SERVICE BULLETIN **Buell**[®]

B-044

SAFETY RECALL CODE 0824 - SHOCK ABSORBER BRACKET

Figure 2. Front Shock Mount

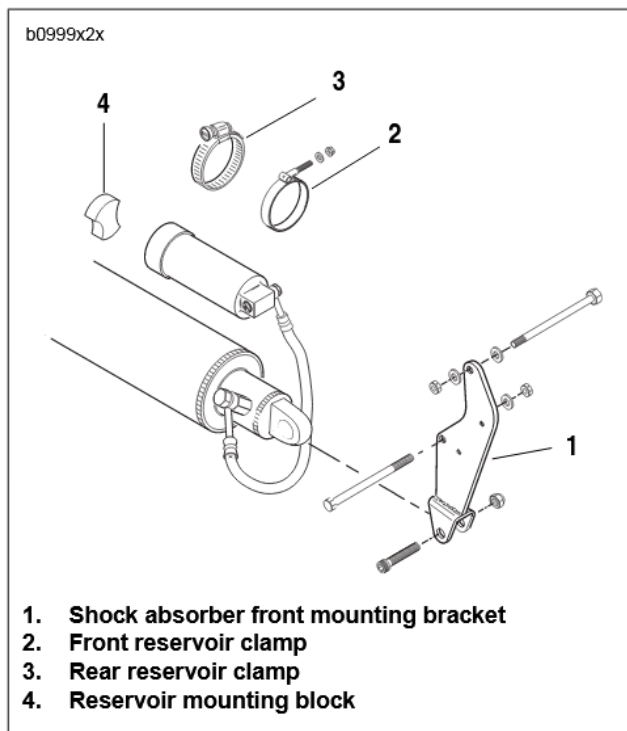
Buell Motorcycle Company has learned that certain 2002 Buell X1, M2, M2L, S3T motorcycles were manufactured between September 12, 2001 and November 14, 2001 with a rear shock front mount, Part Number K0407.01A1, which could be cracked. This condition could cause the shock mount to break, which may allow the suspension to drop unexpectedly. This sudden change in suspension height could cause a loss of control of the motorcycle without prior warning and could result in an accident. Buell Motorcycle Company has voluntarily declared this a defect related to motor vehicle safety (Campaign 0824) to allow us to formally recall all potentially affected motorcycles. The purpose of this bulletin is to announce the release of the proper shock absorber front mounting bracket for the affected motorcycles and to provide installation instructions.

6. Use a flex socket and extension to remove locknut and washer from front reservoir clamp. Discard locknut.
7. Loosen rear reservoir clamp. Slide reservoir out of clamp.
8. See Figure 2. Remove allen screw (metric) and locknut on front shock eye. Discard locknut.
9. Remove (2) crankcase bolts securing the front shock mounting bracket. DO NOT discard locknuts.
10. Remove front shock mounting bracket by pulling down and towards the front of the vehicle.

1. See Figure 2. Loosely install **new** front shock mount to crankcase with original front shock mount bolts, washers and locknuts. Do not tighten fasteners at this point. NOTE: Top bolt goes in from the left side, bottom bolt goes in from right side. Bottom bolt does not use washer under bolt head.

6. See Figure 2. Position front clamp over reservoir. Loosely install reservoir clamp to front shock mount with washer and **new** nylon locknut.
7. Install reservoir mount block between oil pump fitting and remote reservoir.
